KNIGHT CANCER RESEARCH BUILDING

LAND USE REVIEW #1 VS #2 COMPARISON DOCUMENT

LU 15-279775 DZM AD

MAY 02, 2016

PARTIAL FLOOR PLAN - LEVEL 1

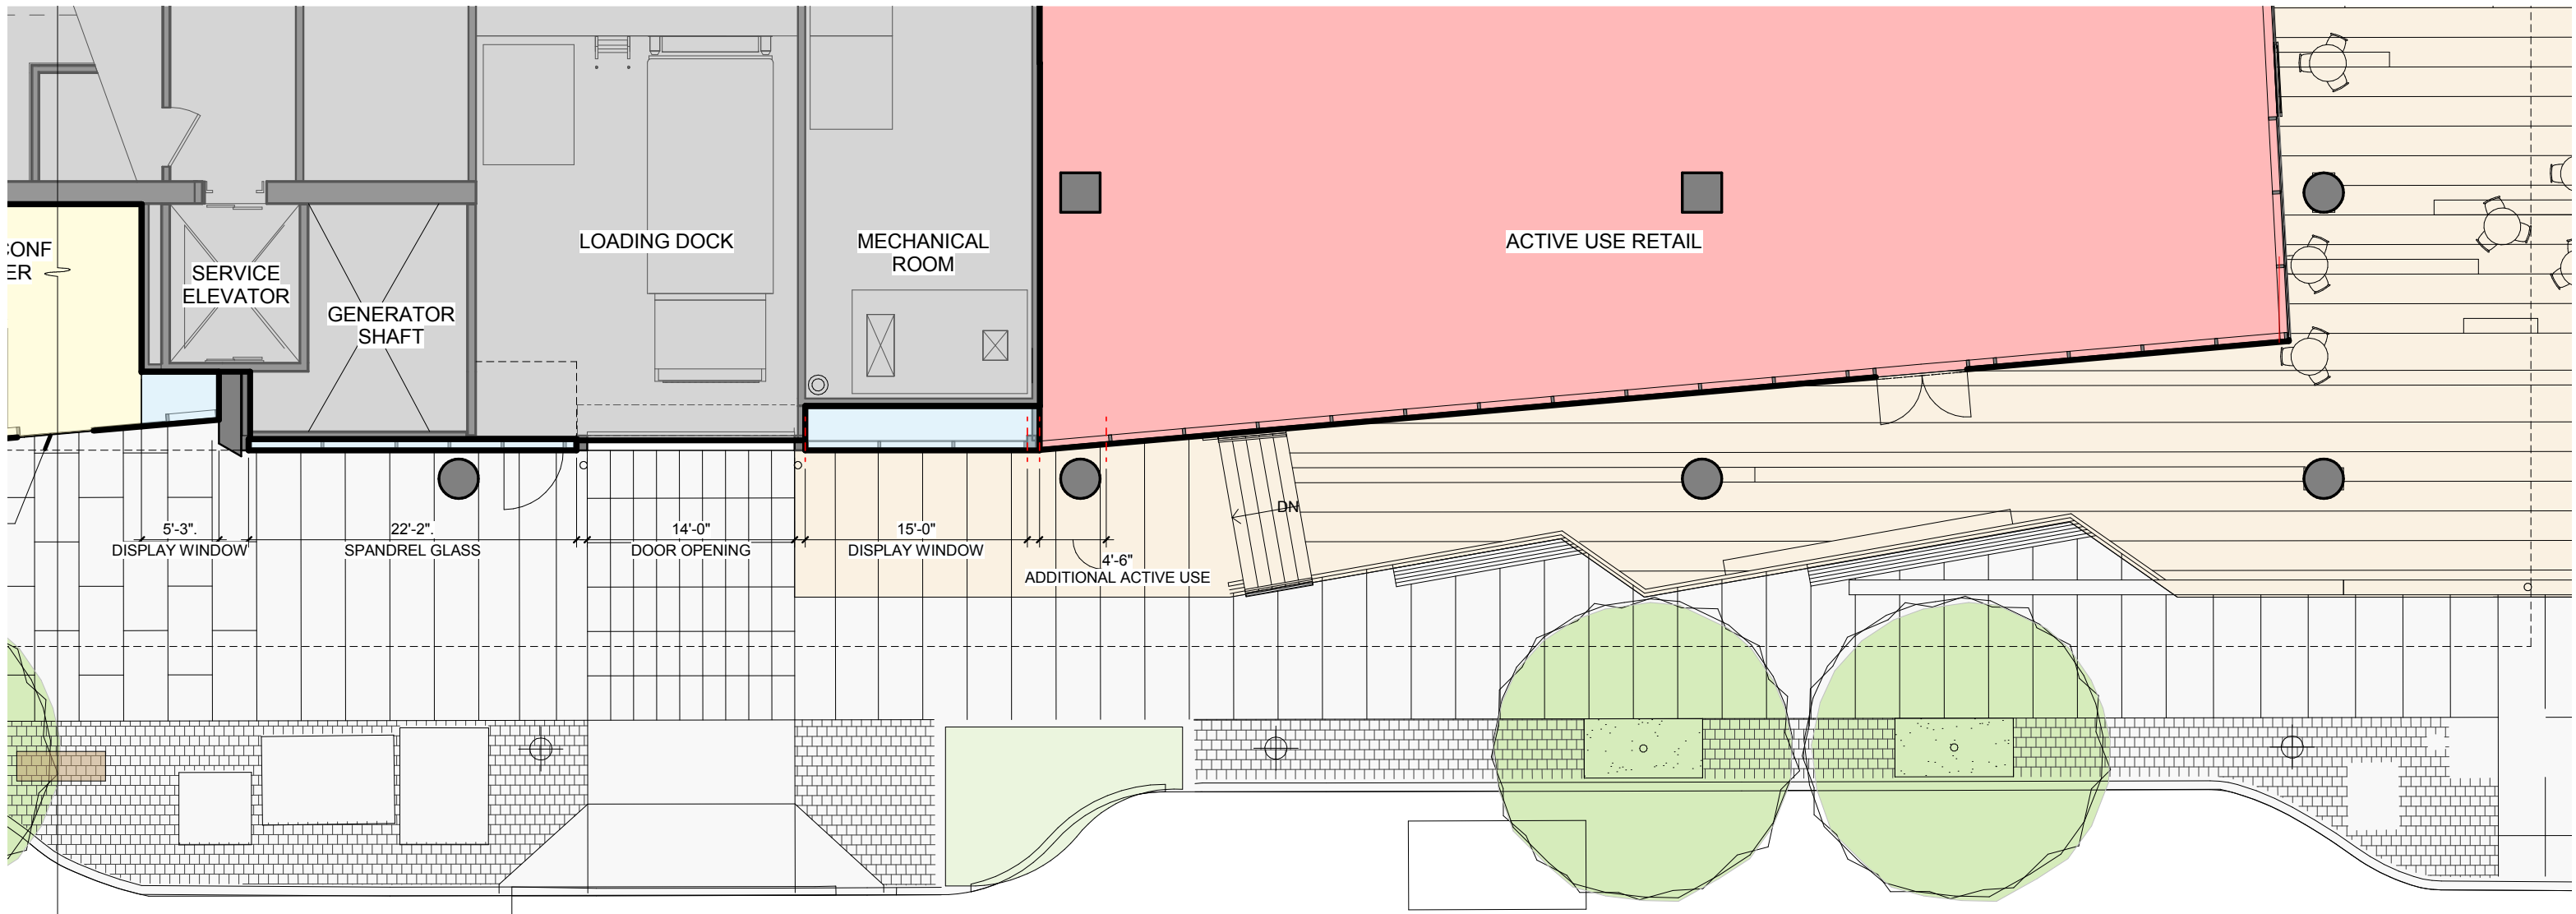
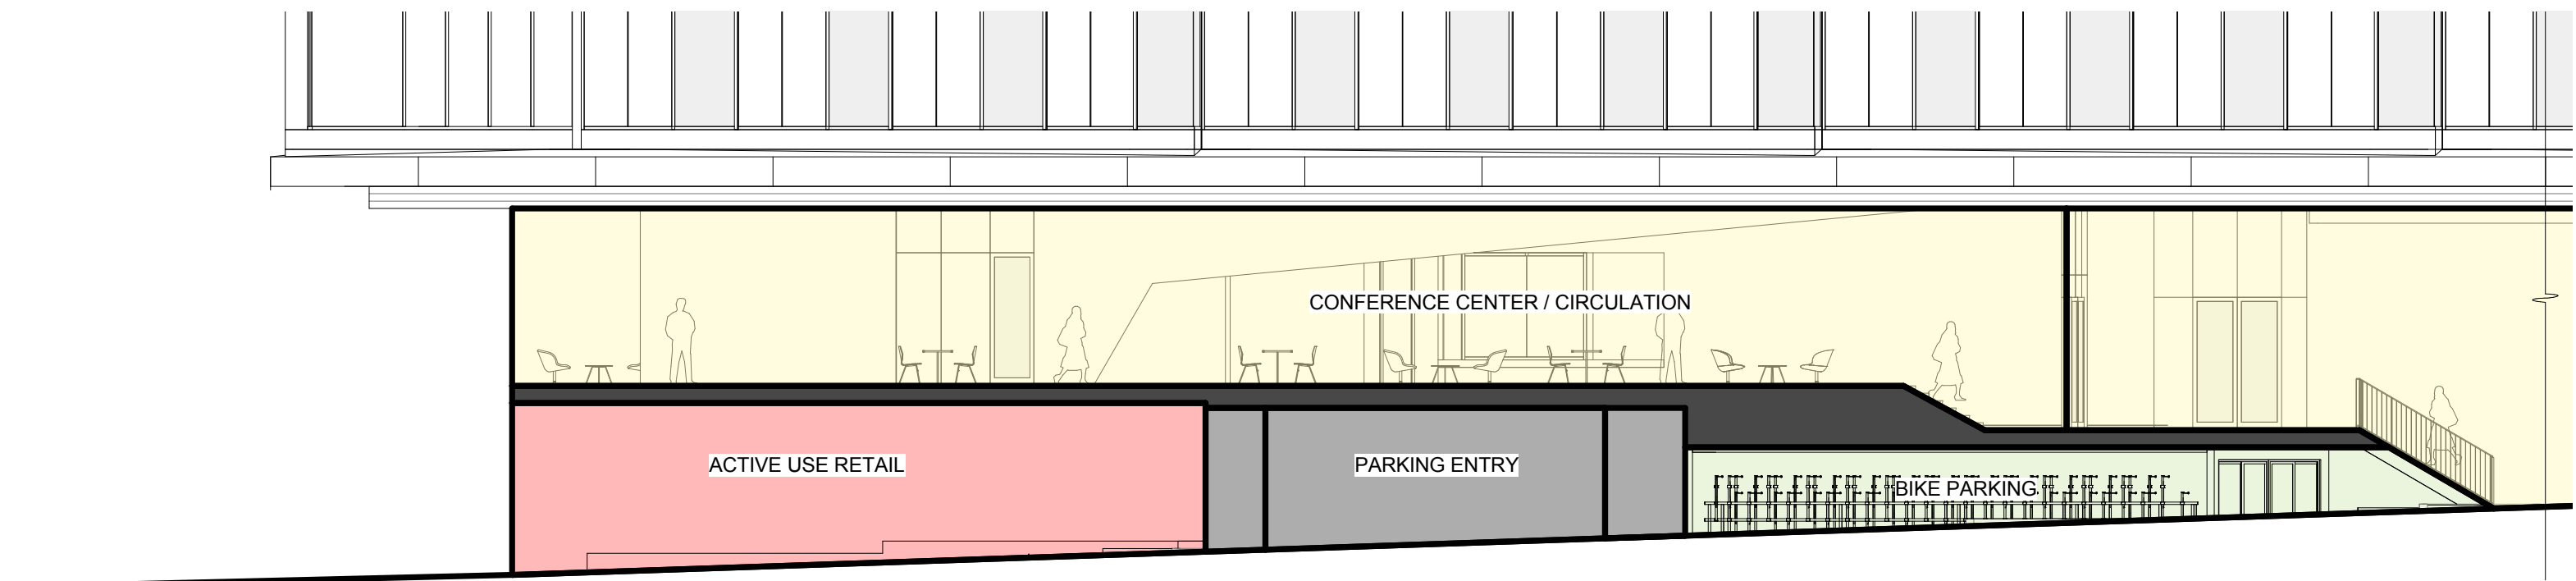
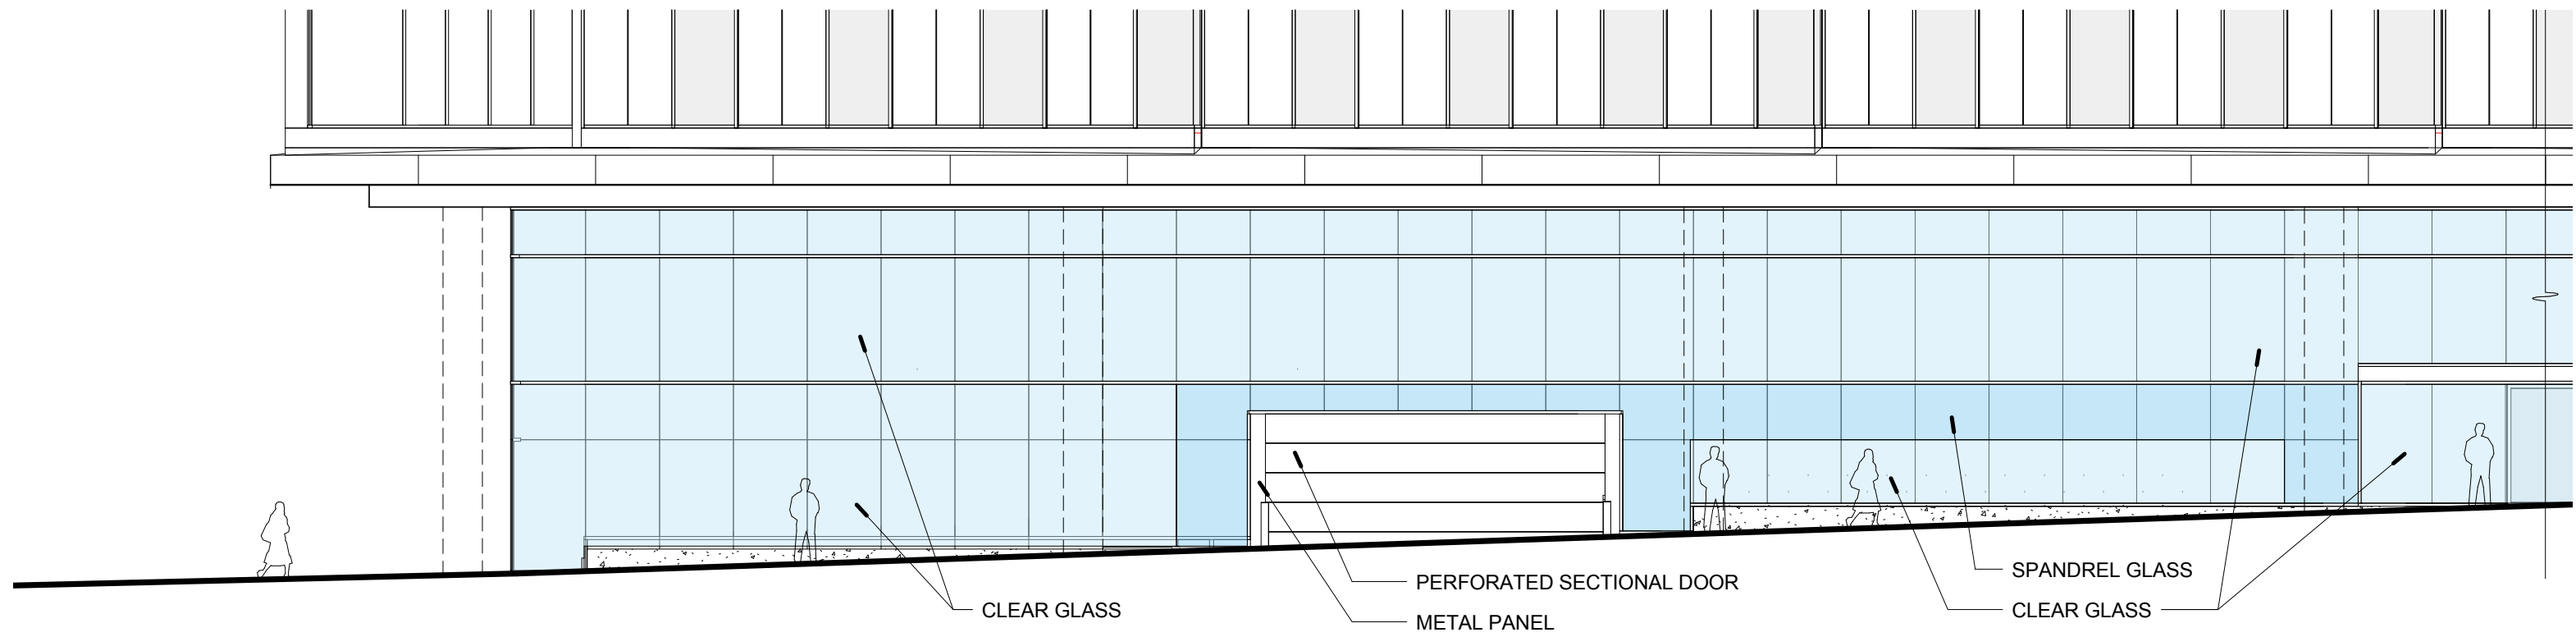
- ADDED 7'-0" OF ACTIVE USE RETAIL AT THE WEST
- REDUCED PARKING ENTRY WIDTH FROM 32'-0" TO 23'-0"
- REPLACED CONCRETE @ PARKING ENTRY WITH SPANDREL GLASS
- MOVED PARKING ENTRY DOOR TO THE BUILDING PERIMETER
- ELIMINATED DOUBLE SERVICE DOORS FROM MEADE ST
- EXTENDED LENGTH OF MID BLOCK ENTRY
- REDUCED MECHANICAL LOUVERS 39% FROM 552 SF TO 337 SF
- ADDED 2' DEEP DISPLAY WINDOW IN FRONT OF MECHANICAL ROOM
- ADDED 4'-6" OF ACTIVE USE RETAIL AT THE EAST
